Group	Mission	Building	Type	Category	Document	Date of Report	Consultant
AMS-B	Bridgetown, Barbados	Chancery	Owned	1 Immediate Occupancy (IO)	Phase 2 Component 2 Seismic Evaluation	December 2013	JL Richards

This document is supplemental to the Bridgetown Chancery Phase 1/2 RSS

Purpose: To confirm seismic performance of the Chancery as per the Phase 1 recommendations and propose remedial options.

### COMPONENT 2 – RETROFIT OPTIONS STUDY

DRAWING:  
**HORIZ. REINFORCEMENT  
 SECOND FLOOR LEVEL**

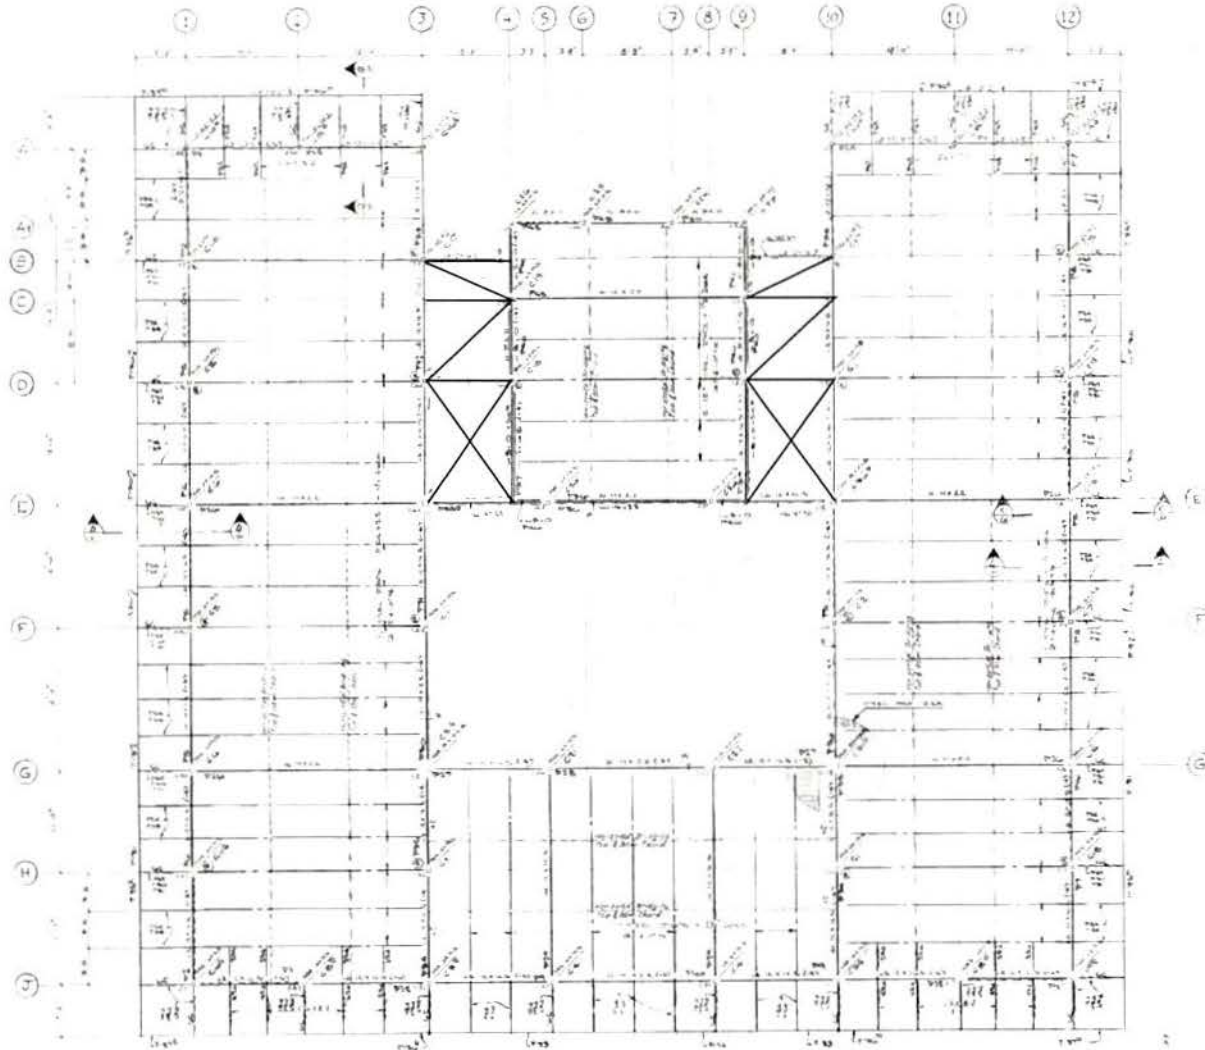
- Improve capacity of roof and second floor diaphragms;
- Improve connectivity of the deck diaphragm to the SFRS;
- Horizontal reinforcement around the second and roof level openings;
- Replacement of existing perimeter chord element with a larger element;
- Upgrade foundation with the use of rock anchors to prevent uplift.

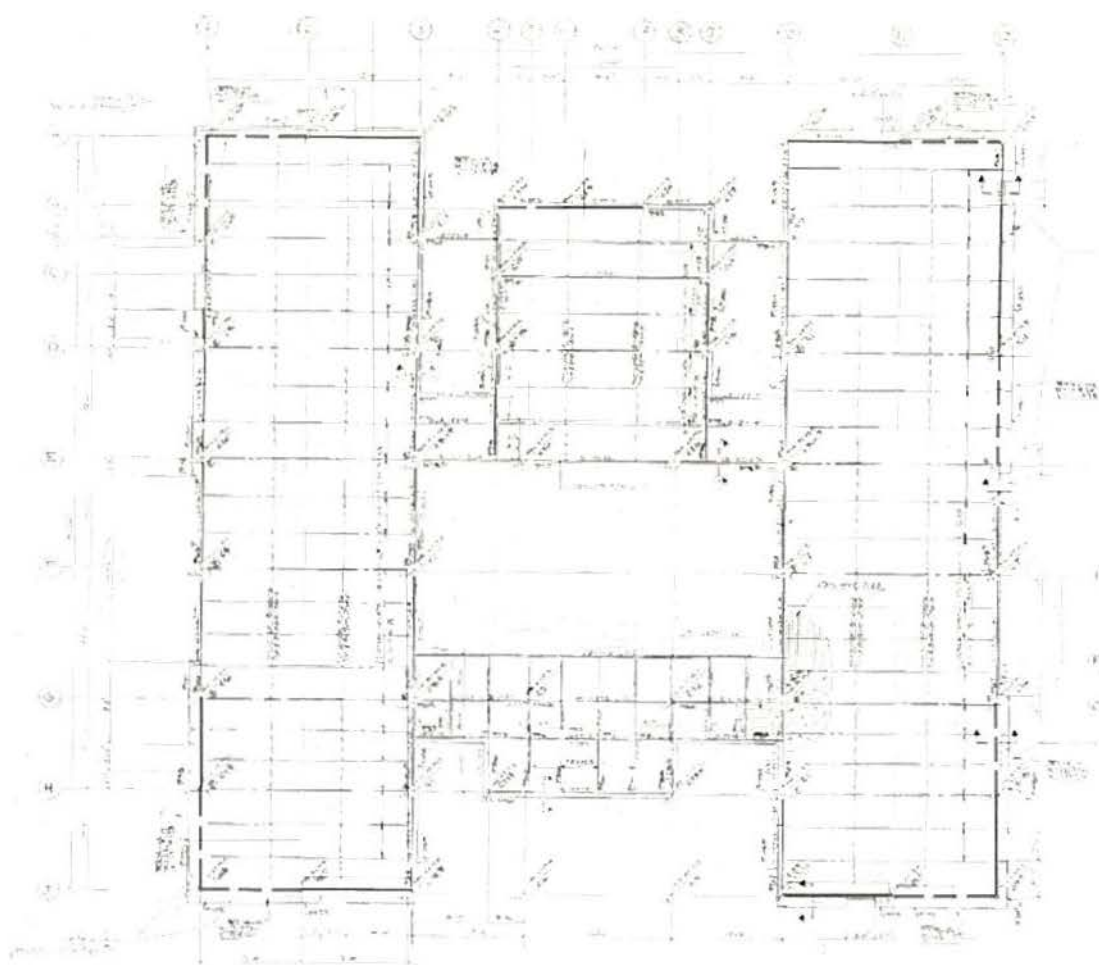
OPTION 1: ADD NEW PERIMETER ELEMENT IN CONJUNCTION WITH REPLACEMENT OF EXISTING ROOFING SYSTEM.

OPTION 2: ADD NEW PERIMETER ELEMENT. ADDITIONAL CONTINUOUS STEEL PLATE WELDED TO EXISTING CHANNEL.

- It is recommended to implement the seismic upgrade to the roof diaphragm concurrently with the roofing membrane replacement.
- It is recommended to proceed with an Option 3 implementation (Phase 3 of the Seismic Program).
